STAFF REPORT

RE: Case No. 14609-MPD (Previously advertised as 14609-UR)

REQUESTS: To consider approval of a rezoning from District B3-2 (Community Business) to District MPD (Master Planned Development) and approval of a preliminary development plan which also acts as a preliminary plat on approximately 1.5 acres generally located on a portion of the block bound by Broadway, W 46th St, W 46th Ter, and Wornall Rd to allow an approximately 293,840 square foot mixed use development.

Figure 1. Illustration of Ground Level at SE, NE and NW Corners of Proposed Development

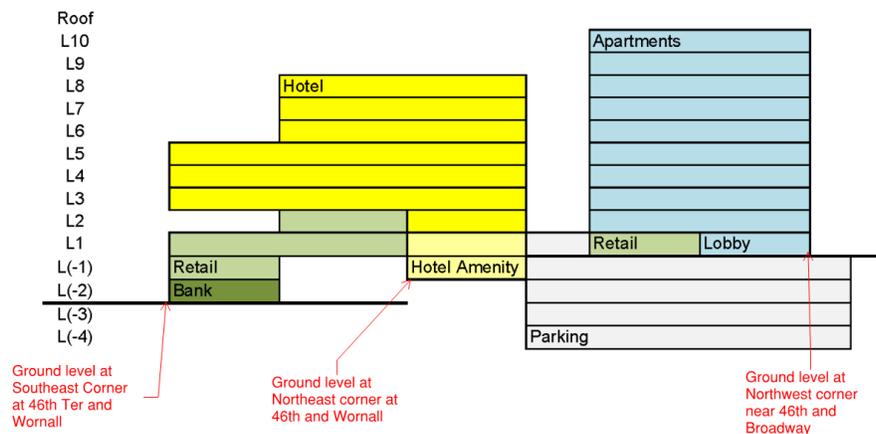
The figures illustrate that the proposed building height is nine stories above grade at the southeast corner and ten stories above grade at the northeast and northwest corners. The plans indicate a varying building height in feet depending upon the portion of the building measured. At its tallest point, the residential component will extend 128 ft above grade at the northwest corner. The hotel will measure 126 ft above grade at the northeast corner, stepping down to 114 ft above grade at the southeast corner of the hotel. The retail component adjacent to the intersection of 46th Ter and Wornall will measure 45 ft above adjacent grade.

Figure 4. Original two "tower" proposal

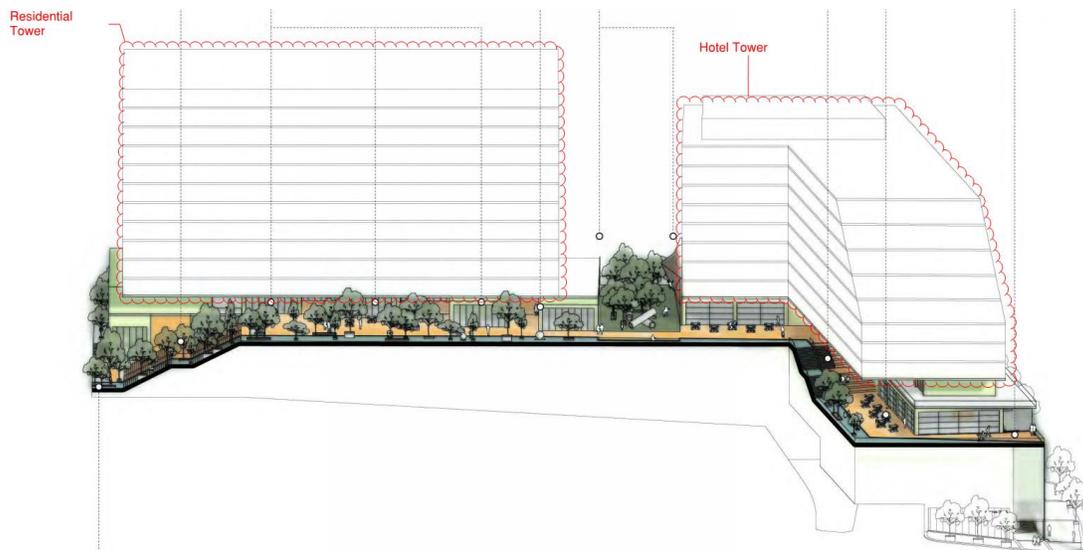
This case was previously heard at the March 1 City Plan Commission hearing and continued to allow staff time to review revised plans. The previous plans provided no information on architectural detail or building materials, but did provide information on the massing, which was in the previous plans and remains in the revised plans a five "towers" design atop a deck which is consistent with the top of the top level of the parking garage. The "towers" are technically two buildings with three of the five "towers" connected to one another forming the hotel component and the remaining two connected to one another and forming the residential component. This massing is one of the major revisions from the original plans which depicted two "towers" (See Figure 4). Staff believes this revision is a substantial improvement from the original for several reasons including that it breaks up the massing of the development, lets more sunlight through to the north and east, and creates a more articulated and interesting skyline.
